Subject: URGENT MEDICAL DEVICE FIELD SAFETY NOTICE- CORRECTION

Reference: ZFA2018-00039

Affected Product: Max VPC Tray Base & Max VPC Screw Caddy Brackets

Affected Brackets (black), please return to Zimmer Biomet Sales Representative

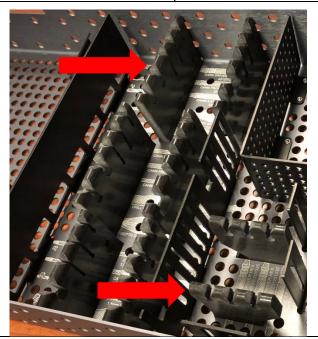
This will be a field based correction. A Zimmer Biomet sales representative will retrieve the product from your account. The brackets being corrected are subcomponents of the Max VPC Tray Base and Max VPC screw caddy, and will be replaced with good brackets. Affected units are identifiable by black brackets. Please use the table on page 2 to identify between affected and already replaced brackets.

Replaced Brackets (gray), do not return the product, it is conforming.
